# Planning Officer Report

93-119 Kavanagh Street, Southbank

Planning Permit Application 2015/32991

### Figure 5- Open Space Diagram

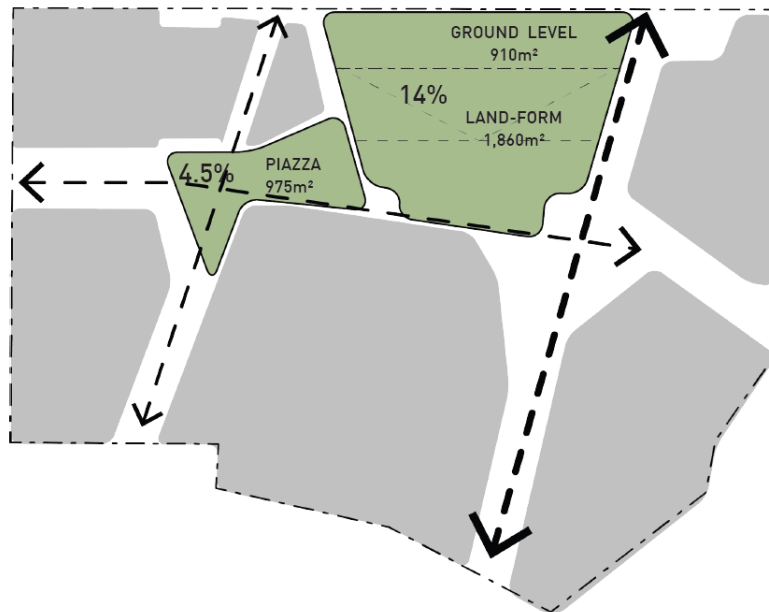
The proposal includes approximately 7,000m<sup>2</sup> of pedestrianised open space at ground level (36% of the site area). The master plan provides dedicated open space primarility througgh two main spaces as shown in Figure 5 below.

Southbank is currently lacking the provision of significant green open space which this proposal addresses, including a zone towards the front of the site to allow for deep planting. The current provisions are limited to the Yarra River's south bank and the Boyd Community Hub and the provision of 3,745m<sup>2</sup> of publically accessible space is applauded.

Figure 6- Tower setbacks to street and tower separation

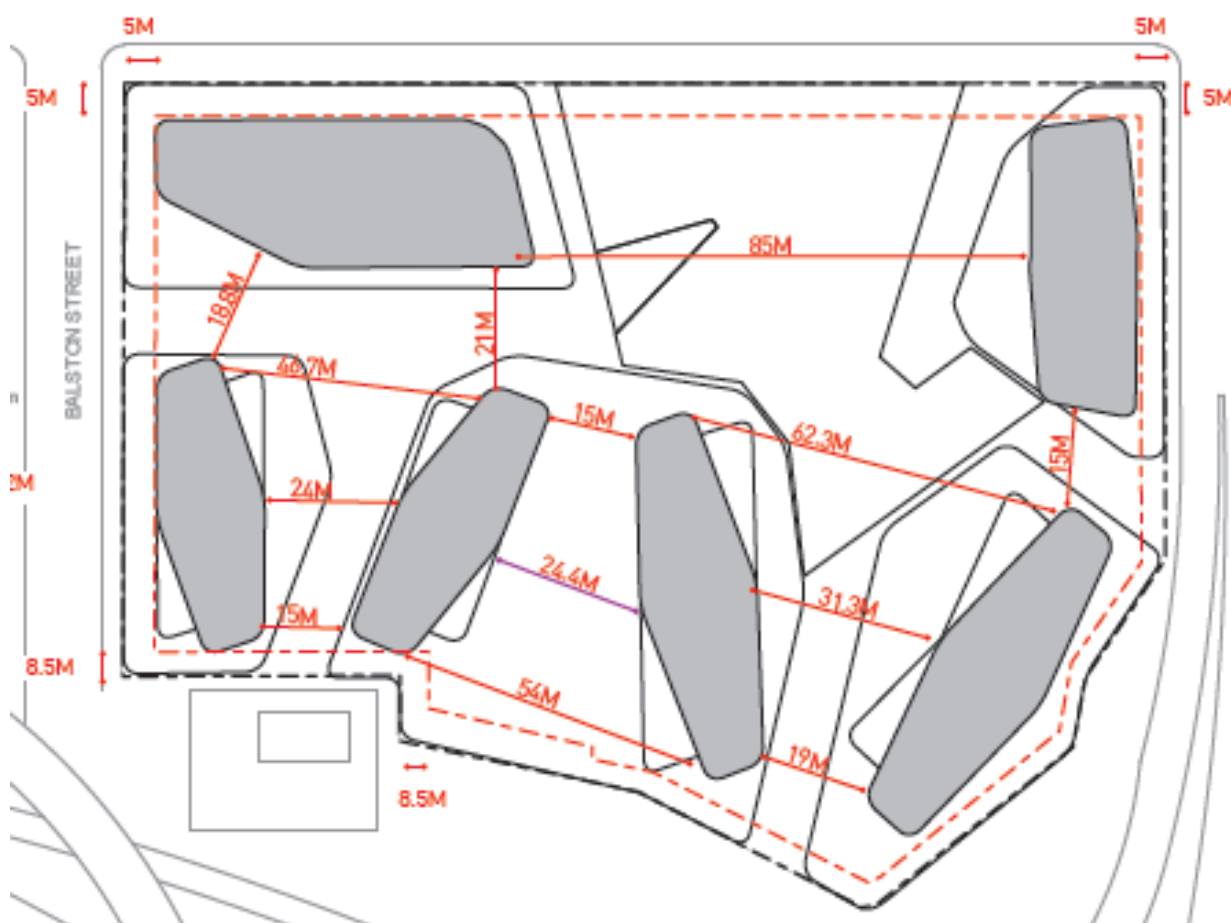
Clause 22.01 does not stipulate a specific measurement for tower separation for developments within the Capital City Zone. The tapered tower forms provide increased setbacks to street frontages and greater average separation at increased heights, achieving minimum tower separations of 15 metres with an average minimum separation of 20 metres. Refer to Figure 6 below.

The towers have been well spaced to equitably distribute access to outlook and sunlight between towers and ensure views of the sky between towers.
